UNITED STATES  
NUCLEAR REGULATORY COMMISSION  
WASHINGTON, D. C. 20555

BIG ROCK POINT PLANT

AMENDMENT TO FACILITY OPERATING LICENSE

Amendment No. 14  
License No. DPR-6

FIGURE 4-1  
Big Rock Point - Reactor Vessel

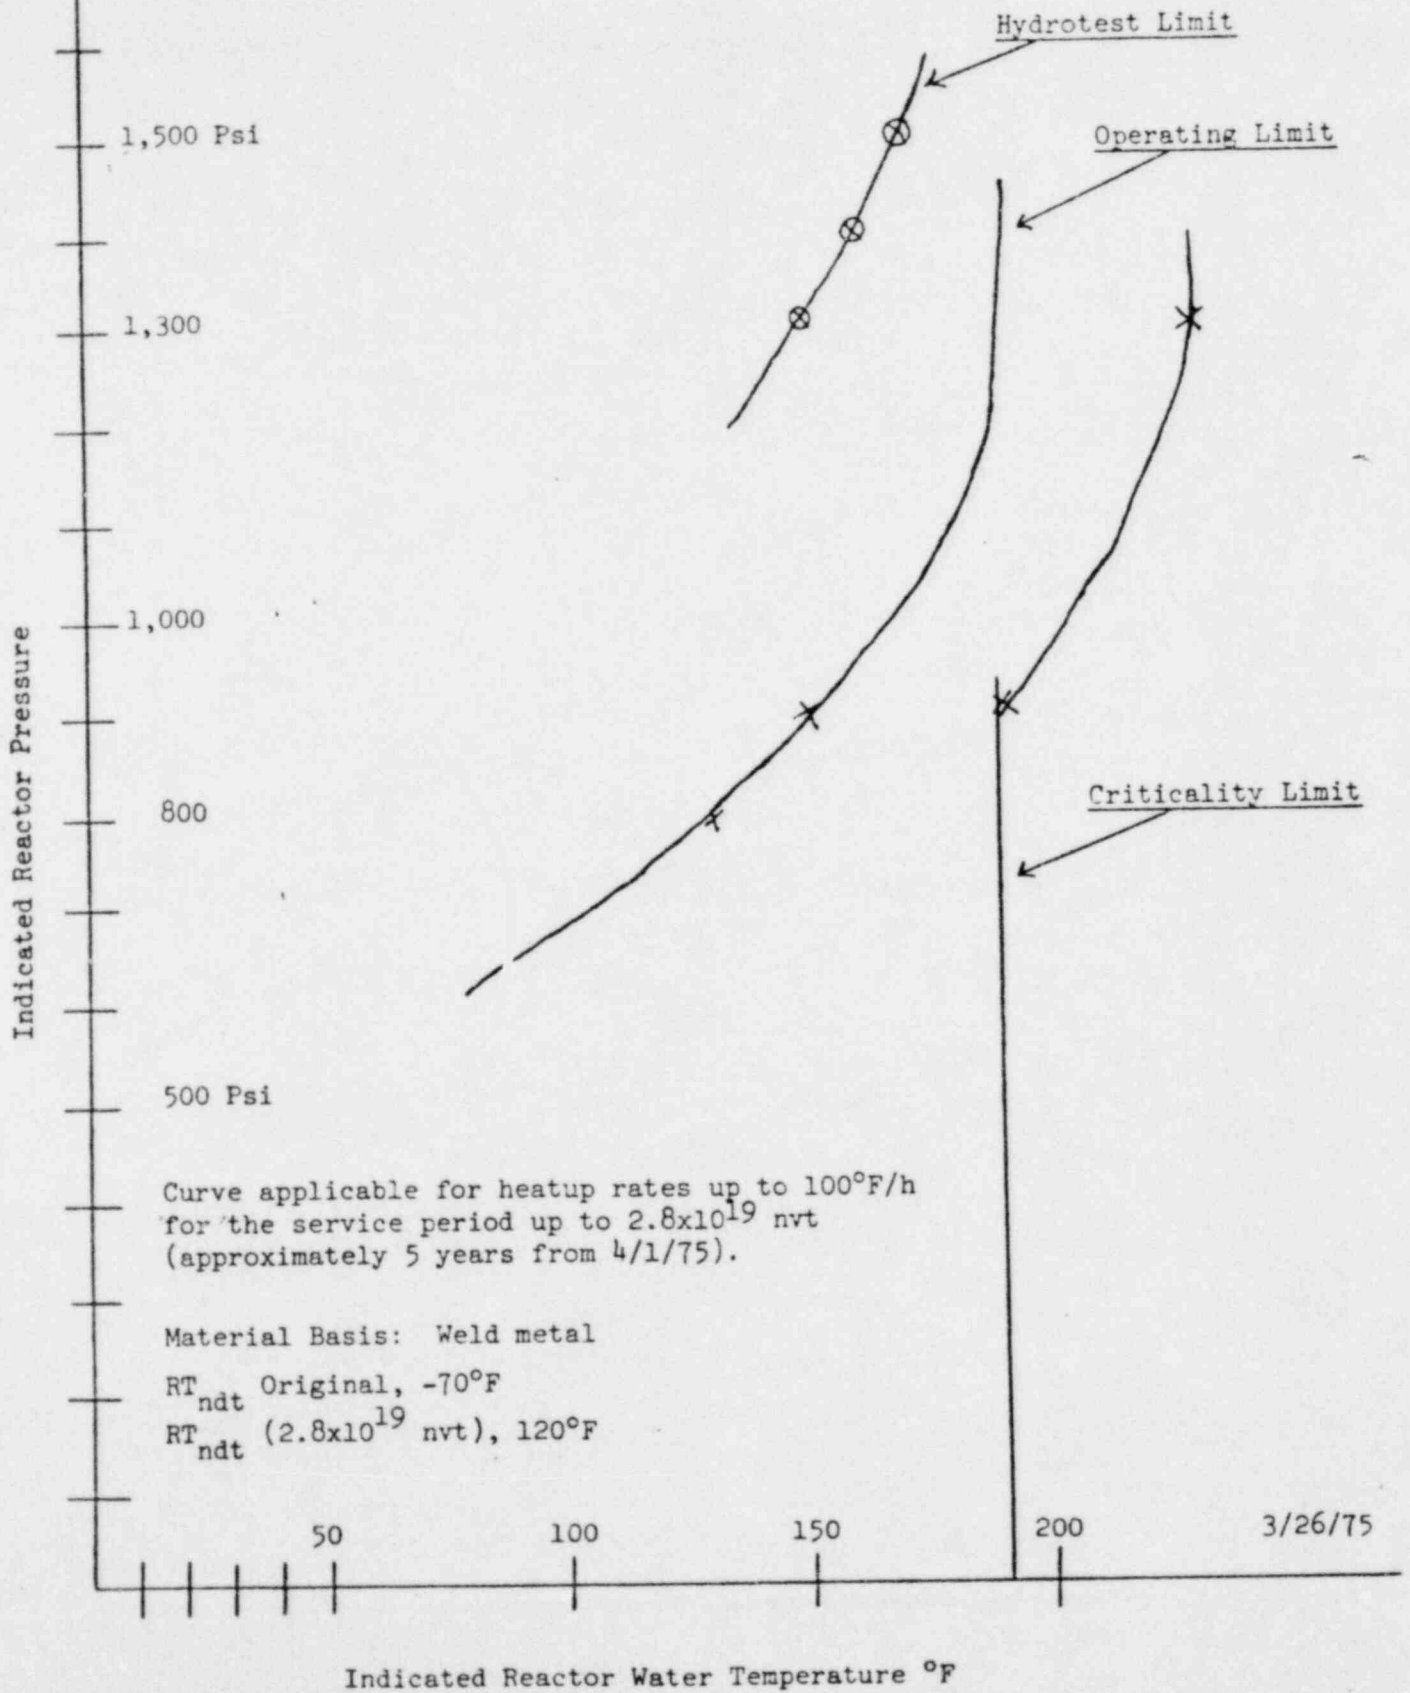
1. The average rate of vessel temperature change during normal heatup or cooldown should not exceed 100°F/h when averaged over a one-hour period.
2. Control rod withdrawal during power operation shall be such that the average rate-of-change of reactor power is less than 50 MW<sub>t</sub> per minute when power is less than 120 MW<sub>t</sub>, less than 20 MW<sub>t</sub> per minute when power is between 120 MW<sub>t</sub> and 200 MW<sub>t</sub>, and 10 MW<sub>t</sub> per minute when power is between 200 MW<sub>t</sub> and 240 MW<sub>t</sub>.
3. Reactor vessel pressure shall be limited in accordance with Figure 4.1.
4. The reactor shall not be made critical, with the exception of physics testing, at temperatures below the criticality limit shown on Figure 4.1.

Criticality, Cooldown, Heatup  
and Hydrotest Limitations
